DEVELOPMENT ASSESSMENT REPORT
Shire of Augusta Margaret River
28 April to 4 May 2022

DEVELOPMENT APPLICATION ASSESSMENT
Report to Manager Planning and Development Services

Proposed Group Dwelling x 4 at 20 (Lot 62) Le Souef Street Margaret River

P221874; PTY/676

Figure 1: Ridge height variations

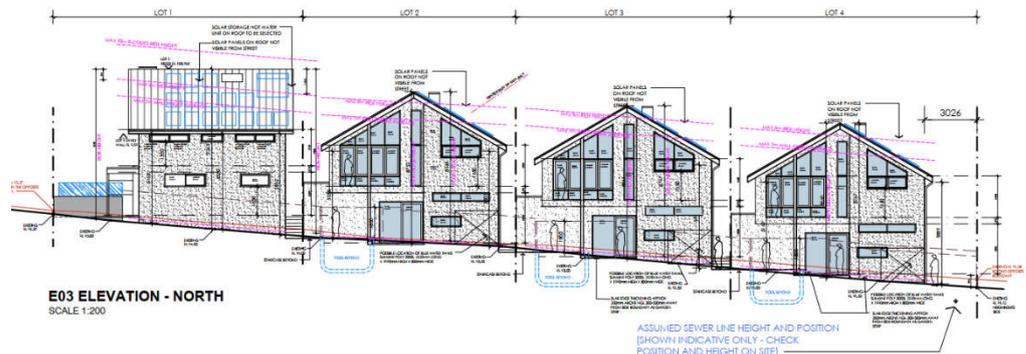
Development Standards (Schedule 9)			
Are the development Standards applicable?		<input type="checkbox"/> Yes	<input checked="" type="checkbox"/> No
Car Parking			
LPS1 / R Codes Requirement	Car Bays Required - <8>		Car Bays Proposed - <8>
Dimensions	2.5m x 5.5m	<input checked="" type="checkbox"/> Complies <input type="checkbox"/> Doesn't Comply	
Turning Bay/Circles and vehicle manoeuvring	<input checked="" type="checkbox"/> Complies <input type="checkbox"/> Doesn't Comply		
Disabled Bays	Disabled Bays -N/A	<input checked="" type="checkbox"/> Complies <input type="checkbox"/> Doesn't Comply	
Officer Comment	The development complies with the parking requirements of the R-Codes providing a double garage for each unit.		
Building Height			
Scheme Requirement	Wall - 7m <input checked="" type="checkbox"/> Complies	Roof - 8m <input checked="" type="checkbox"/> Doesn't Comply	
Proposed Ridge Heights	Lot 1: 9.5m (rear/west)	8.6m (front/east)

Lot 2: 8.752m (north)	8.643m (south)	
	Lot 3: 8.967m (north)	8.747m (south)	
	Lot 4: 9m (north)	8.747m (south)	
Officer Comment	<p>The Unit 1 ridge height was amended by 500mm from the originally advertised proposal based on height concerns. The amendments were achieved by reducing the wall height and the amended proposal has a maximum wall height of 6.24m at Unit 1. Notwithstanding, the ridge height of all four grouped dwellings exceeds the LPS1 requirement of 8m.</p> <p>The amended proposal involves significant variations to the ridge height standard with a maximum 1.5m height variation arising for a portion of the Unit 1 ridge as shown in Figure 1 below.</p> <p>The applicant has provided justification for the proposed ridge height variations as follows:</p> <ul style="list-style-type: none"> There is a notable 4m difference in height from the rear of the site to the front lot boundary. With the development proposed along the natural ground level reducing extensive amounts of site works and retaining along the boundary which would have a negative impact on neighbouring properties.

1. The proposal fails to comply with clause 5.13.1(b) of the Shire of Augusta Margaret River *Local Planning Scheme No. 1* (the Scheme) because it exceeds the 8m ridge height standard by 1.5m.
2. Site constraints, functional requirements or any other extraordinary circumstances do not exist to justify the variation to the proposed ridge height as required at Scheme clause 5.13.2.
3. The proposal fails to comply with clause 4.21.4 of the Scheme given the unacceptable height and scale of the development and the lack of landscaping in the front setback area which renders the development incompatible with existing development in the locality.
4. The proposal is inconsistent with the Deemed Provisions of the Scheme, Matters to be Considered at clause 67, with specific regard to the following:

Figure 2: Unit 1 Le Souef Street frontage

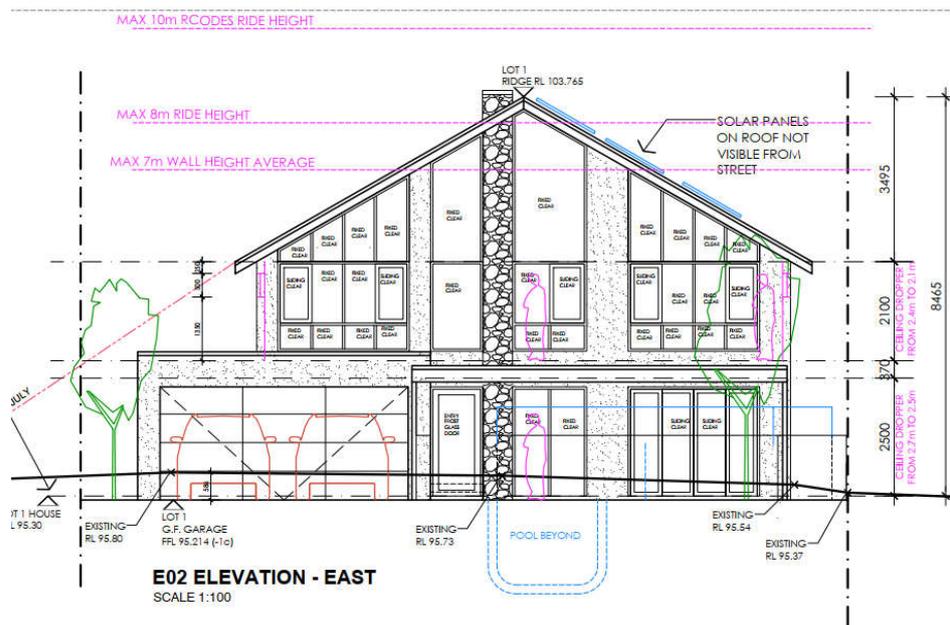
<u>Landscaping</u> The proposal seeks a variation to the landscaping requirement of the R-Codes (clause 5.3.2 C2.2) which requires landscaping of the street setback area with not more than 50% of this area to consist of impervious surfaces. The development proposes only 18.1% of landscaping within the street setback area largely due to the proposed Unit 1 driveway from Le Souef Street.		
	The applicant advises that the existing topography of the site makes vehicle access to Unit 1 from the proposed common property driveway unfeasible. Evidence to demonstrate the need for the additional access to the street has not however been provided.		
	There is concern that the excessive impervious surfaces and lack of landscaping in the front setback is in conflict with the design principles of the R-Codes and does not contribute positively to the amenity of the development or the streetscape. Further the lack of landscaping in the front setback area is in conflict with LPS1 intent for development at the R40 density to ensure landscaping between the building and the street. The proposal does include one tree for each dwelling that would be located abutting the accessway improving the amenity of this area and the proposal also retains two street trees. The lack of landscaping in the front setback area however, conflicts with the Scheme and R-Codes standards. Accordingly, the proposal is considered unacceptable in this regard.

- The finished floor level of Unit 1 cannot be dropped given the driveway level gradients down into the garage are currently at a max which are 1:8 for the 2m transition max 1:5 slope down to garage from the existing verge/street levels. This results in an increased height at the rear of the ridge.

- The street level and verge is 700mm higher than the proposed Unit 1 finished floor level and therefore the development will not be perceived as over height from the street.
